Our Cultural Heart

Phase 2, Kirklees, Huddersfield

Design and Access Statement

Document No:	IR430300-CTA-ZZ-XX-RP-A-00017
Revision No:	P02
Date:	24.04.2026
Authored by:	AC
Checked by:	AN

Proposed Basement Layout

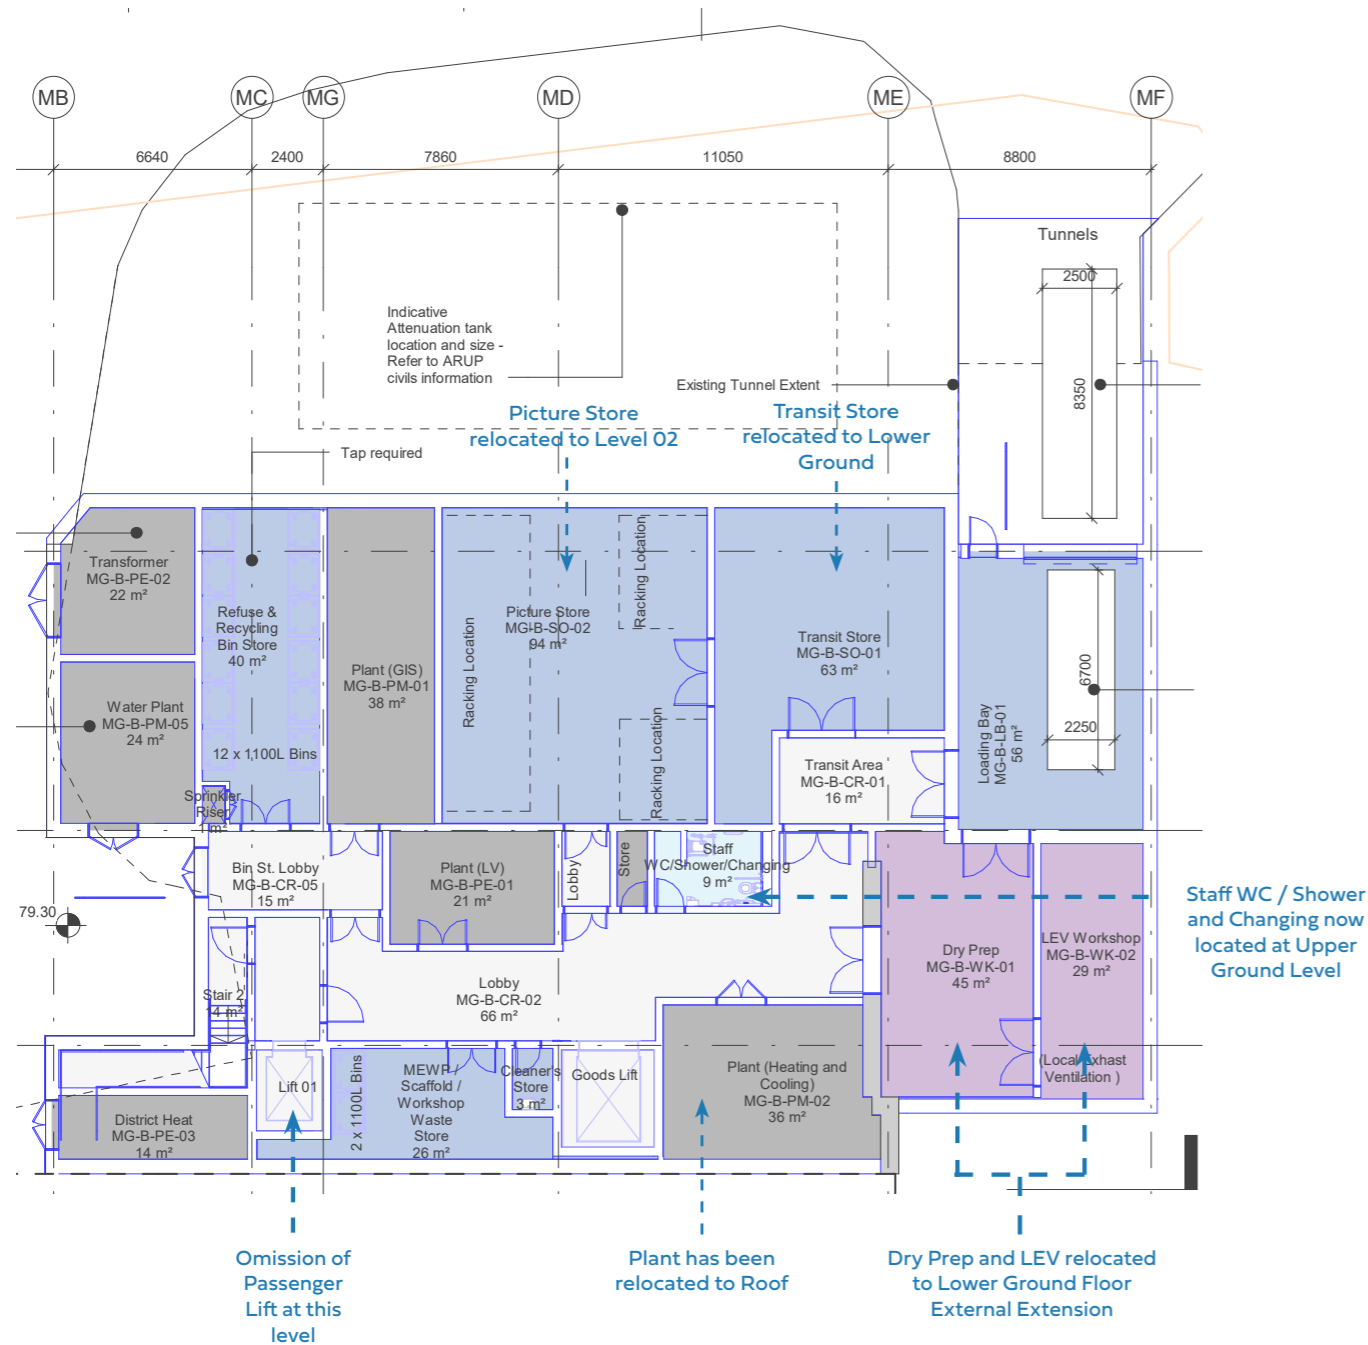
As part of the RIBA Stage 2 redesign, the extent of the new basement was reviewed and the design team developed a revised proposal, in conjunction with the current client brief and in collaboration with the Kirklees Council Museum and Gallery (MAG) team.

As the building services design was developed in more detail, it was apparent that a reduced area of plant space within the basement could be achieved. In addition, cycle storage and workshop areas are relocated to the lower ground floor to improve operational efficiency.

Proposed Lower Ground Floor Layout

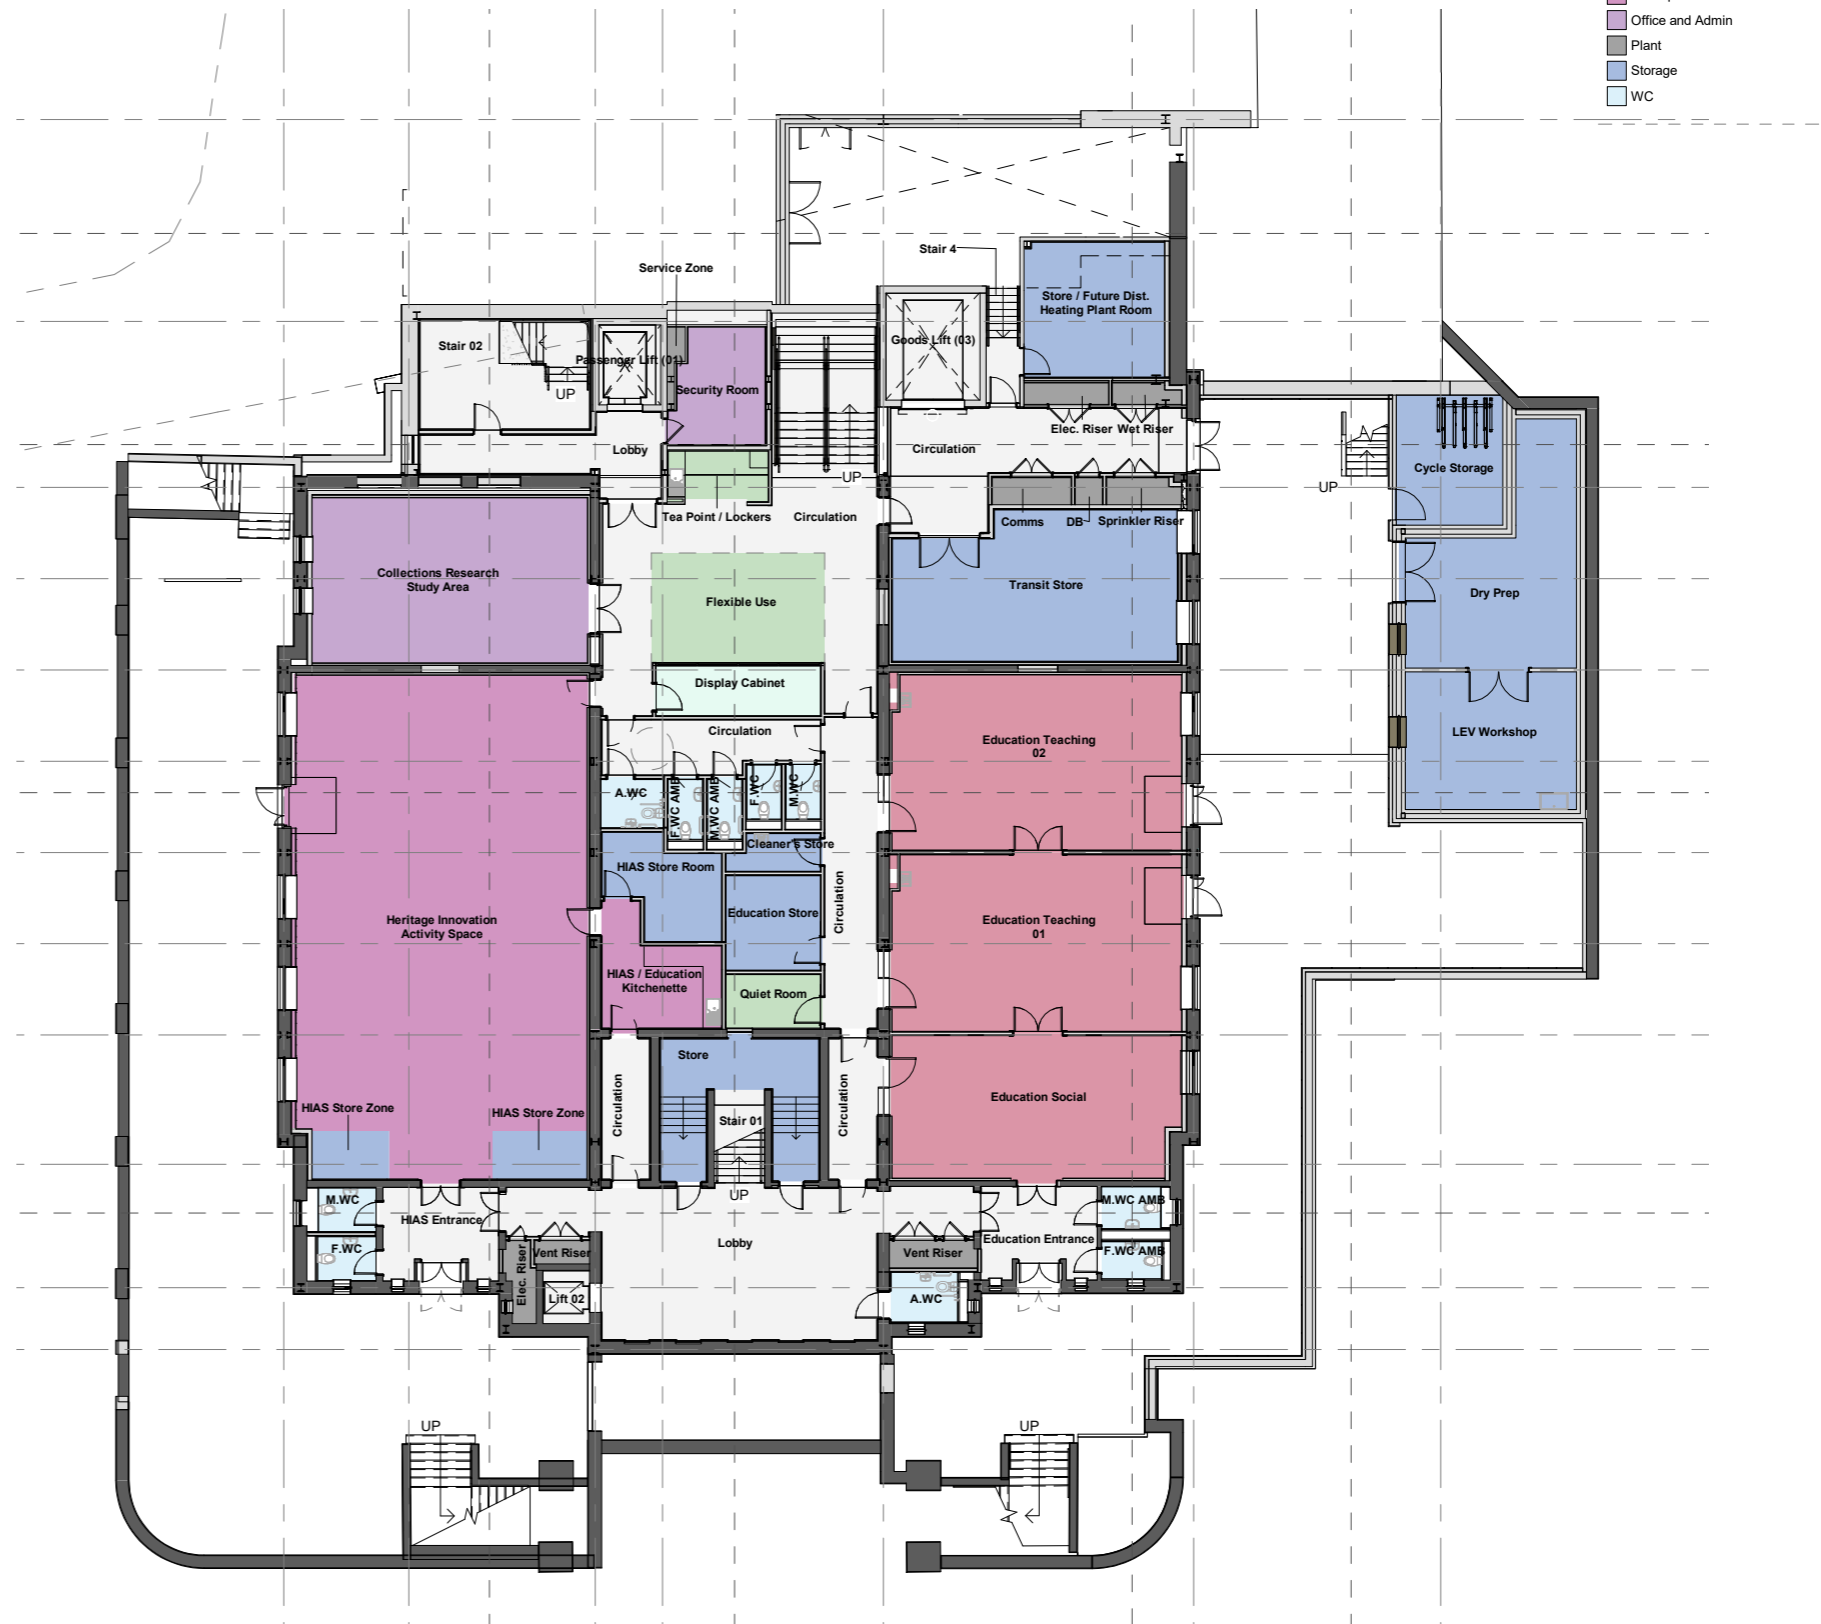
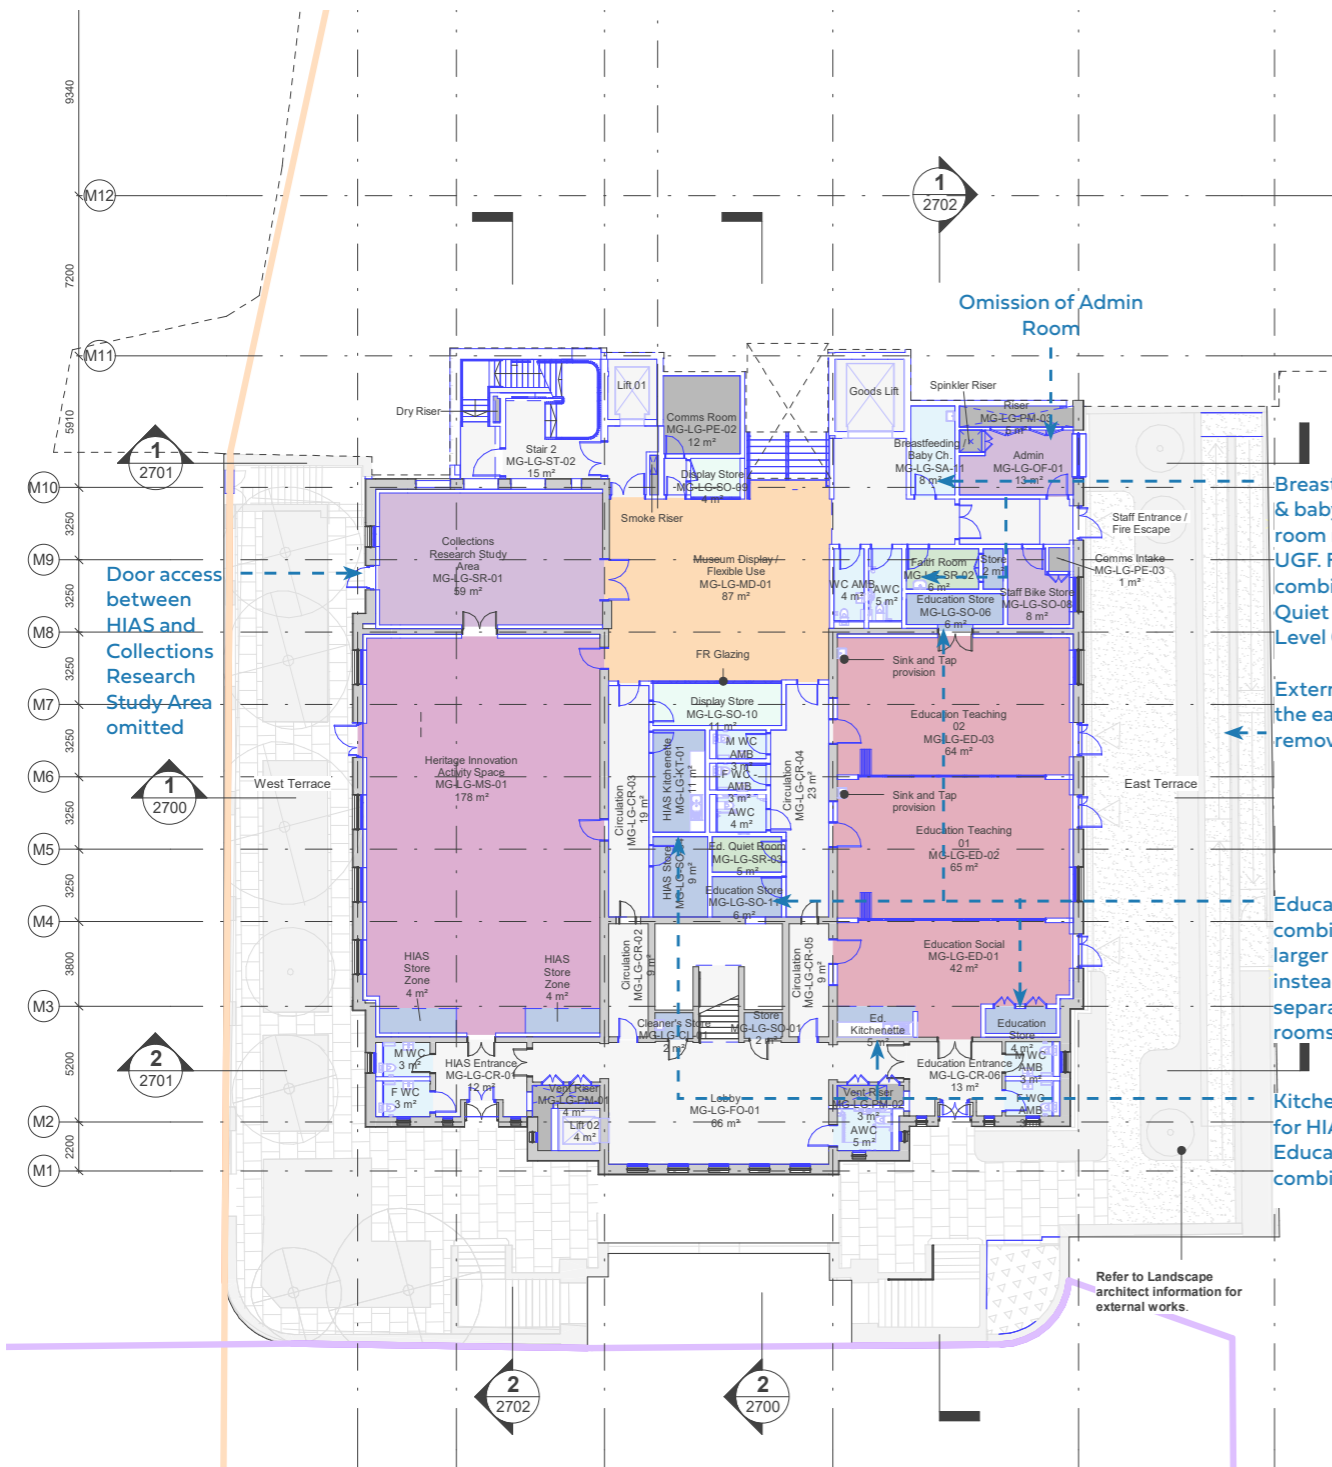
The Lower Ground Floor has been further developed with the Kirklees Council Museum and Gallery (MAG) team and key stakeholders through a regular series of engagement meetings throughout the design development process.

The internal amendments are minor and have limited impact on the existing fabric of the building and there are only minor differences when compared to the consented scheme.

Externally, the number of new openings formed in the existing façades has been reduced, helping to retain more of the existing façade in its original state.

The external courtyard has been redesigned, to create a private external courtyard for the education spaces, where visiting children can enjoy the outdoors within a secure and private environment. A separate external back-of-house (BoH) space is created for staff use, giving access to the new workshop, dry prep area and staff cycle storage. These spaces make use of the existing retaining wall that links to the service tunnel beyond, reducing the amount of demolition required from the consented scheme.

Proposed Upper Ground Floor Layout

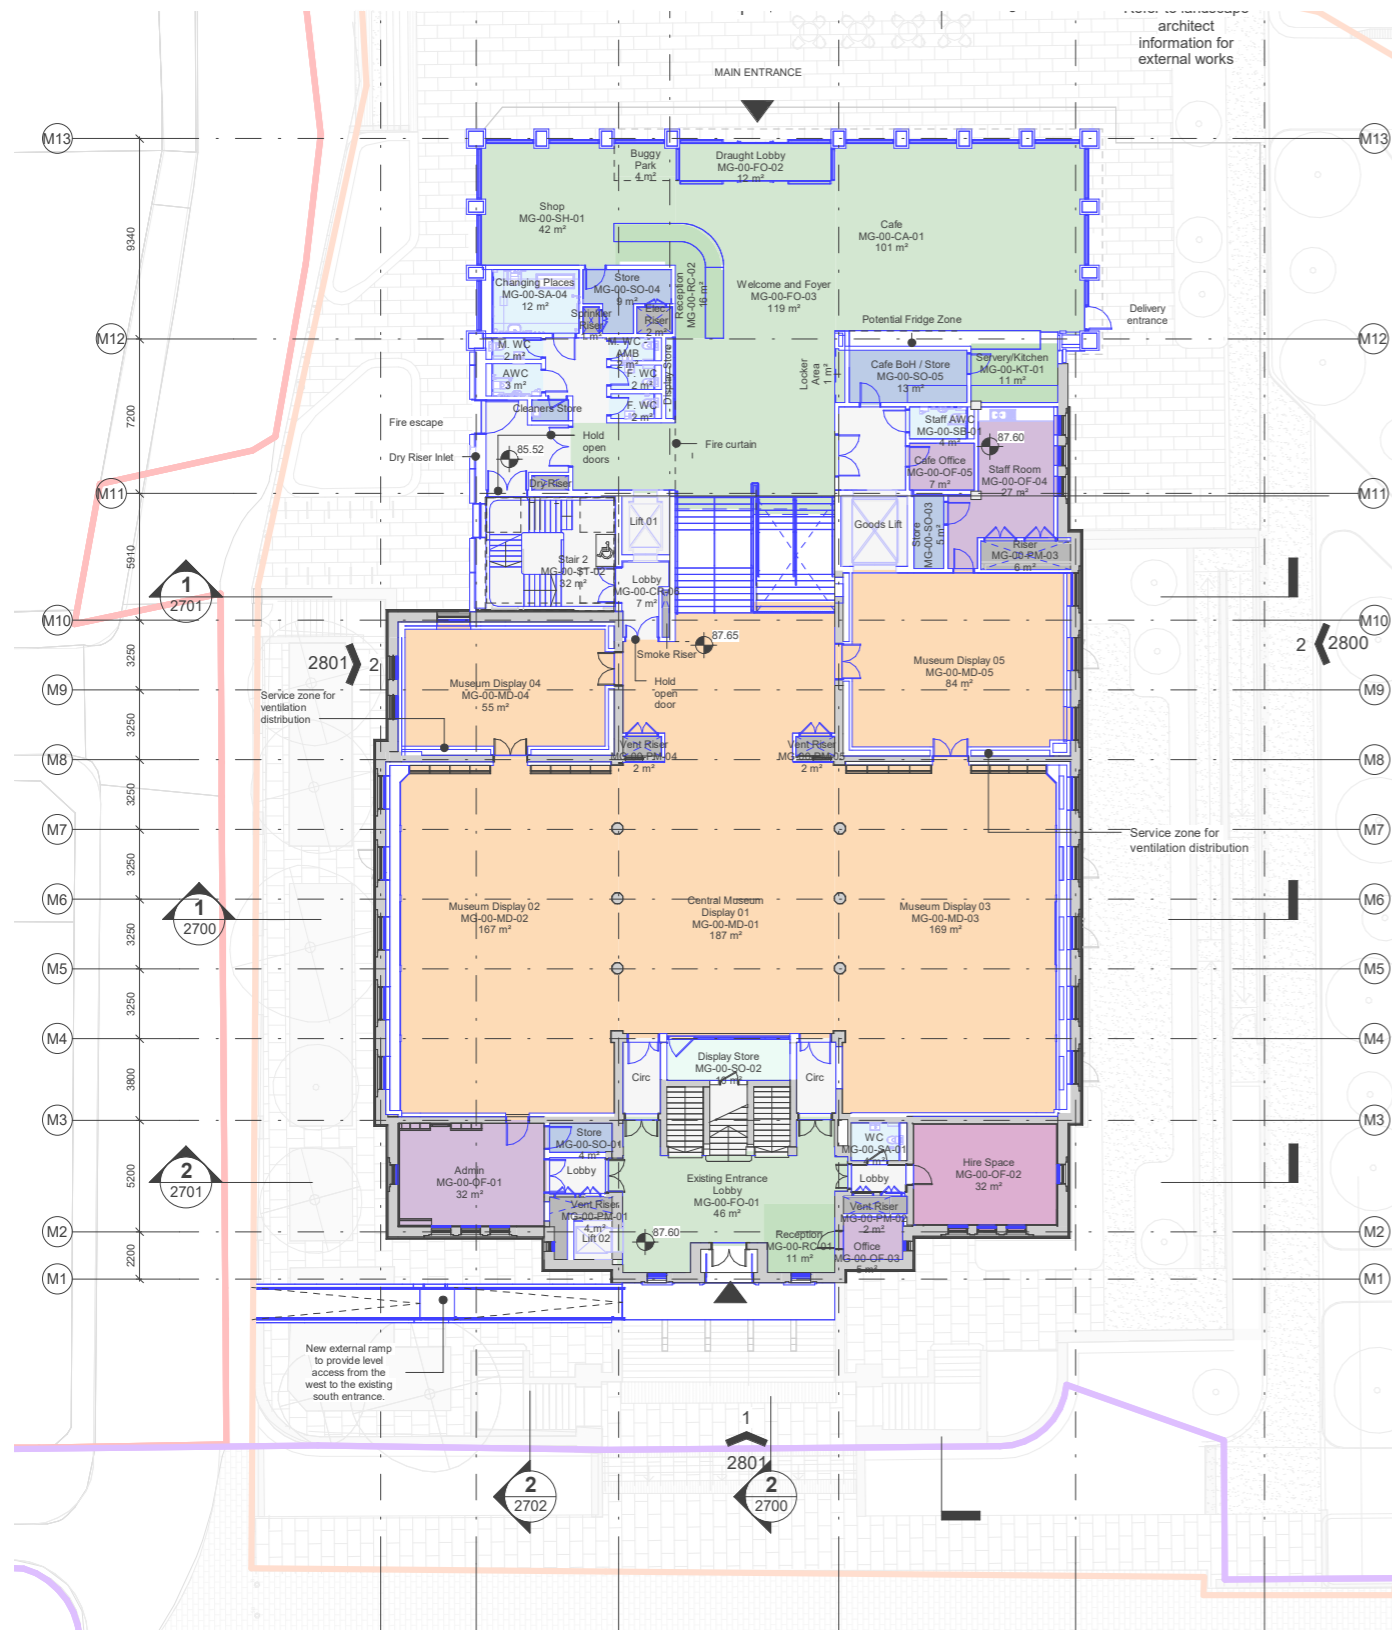
The principles of the consented scheme are retained, with the new entrance, café space and shop located in the new extension to the north, leading to the display spaces and circulation cores beyond. To the south, the new ramp provides step free access/ egress to the existing southern entrance.

The internal layout has been further developed and rationalised to ensure that this complies with the requirements of the building regulations and the operational requirements for the end user Kirklees Council Museum and Gallery (MAG) team.
